Alexander Stadium Redevelopment

Summary of the updated design for the Northern Plaza
January 2021

Original design for the Northern Plaza

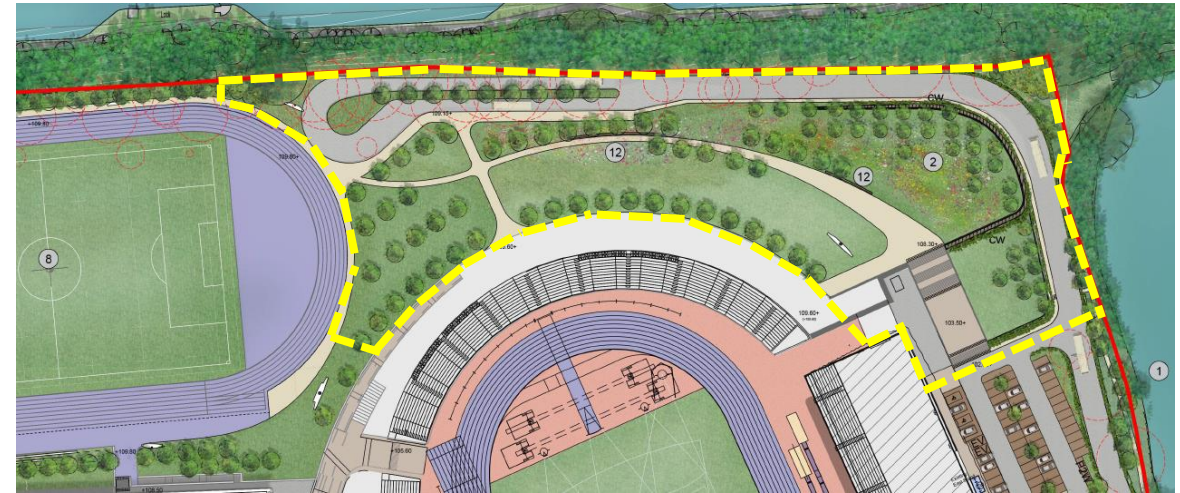
The 'Northern Plaza' area is outlined in yellow on the plans below. These plans were approved by Birmingham City Council as part of the original planning application for the Alexander Stadium Redevelopment.

Updated design for the Northern Plaza

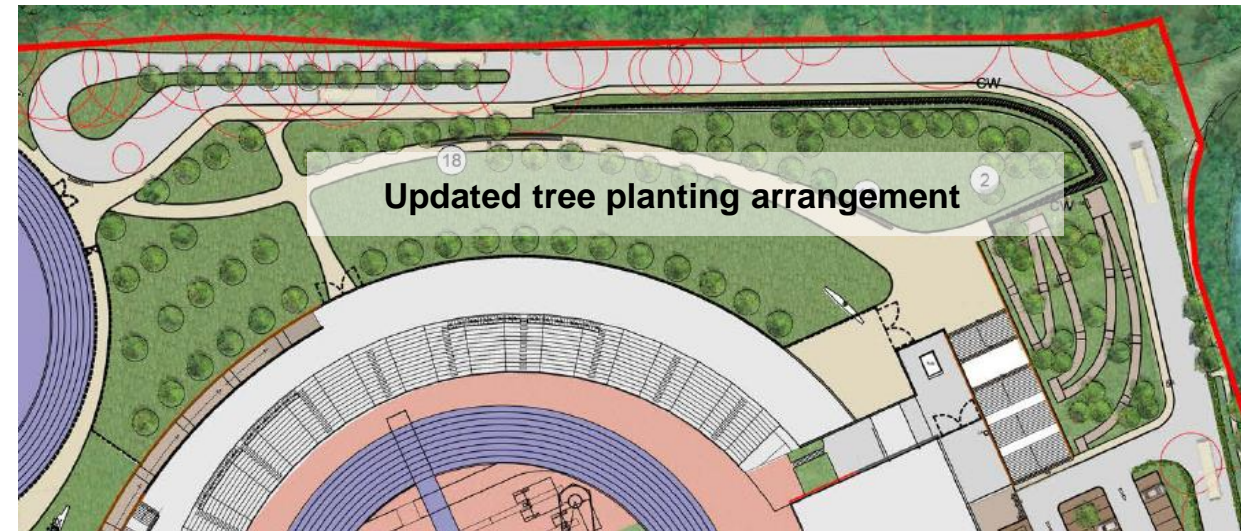
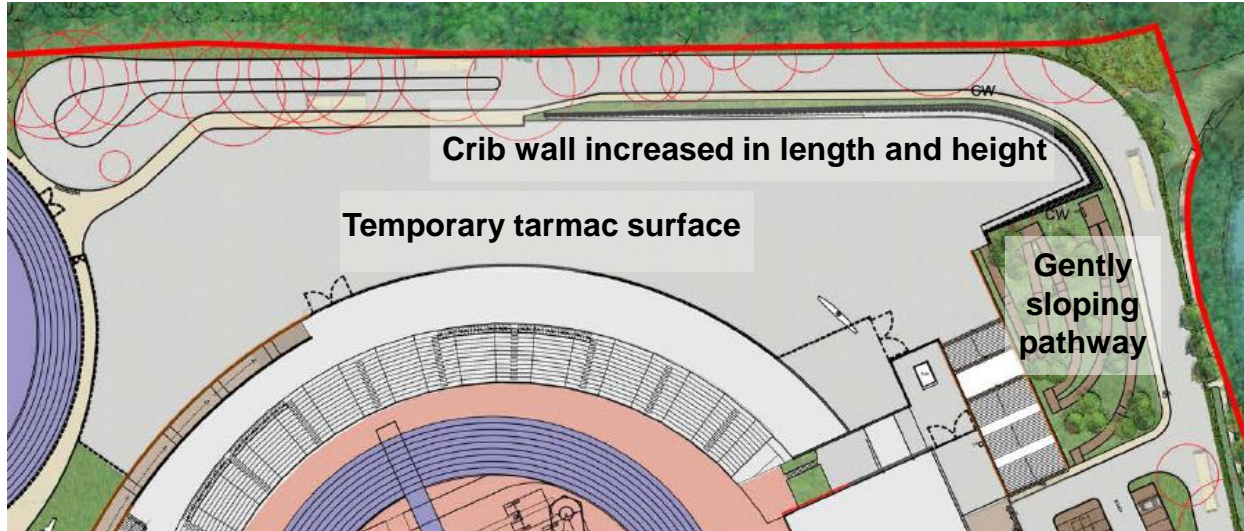
The following changes are required to the design of the Northern Plaza:

- Addition of a temporary tarmac area as part of the ongoing stadium construction works, to provide a flat surface for the temporary additional seating required for the Birmingham 2022 Commonwealth Games. Originally, this work was going to be undertaken by the Commonwealth Games Organising Committee at a later date. After the Commonwealth Games, the tarmac surface will be removed, and the area will return to grass with new pathways, trees and wildflower planting.

- Changes to site levels in the area to provide a larger flat surface to ensure there is adequate space for the temporary additional seating, and enough room behind the seating stand to allow safe access. The original proposal included a gentle slope between the Northern Plaza and Athletes' Route, this area will now be made level, and the crib wall (*a wall made of timber slats containing stone used to prevent the movement of soil*) will be increased in height (by around 1.4 metres) and extended further to the west.

- Addition of a gently sloping pathway between the East Stand car park, and the Northern Plaza and East Stand levels. This will enhance access to the stadium, and is an improved scenario when compared to the original proposal which only included steps in this area. Ahead of the Commonwealth Games, the area surrounding the pathway will be planted with trees.

- In order to avoid drainage tanks in this area, the location and number of new trees across the Northern Plaza has changed since the original proposal. As a result, there will be three fewer trees provided in the Northern Plaza area, but consideration will be given to alternate locations to plant these trees.
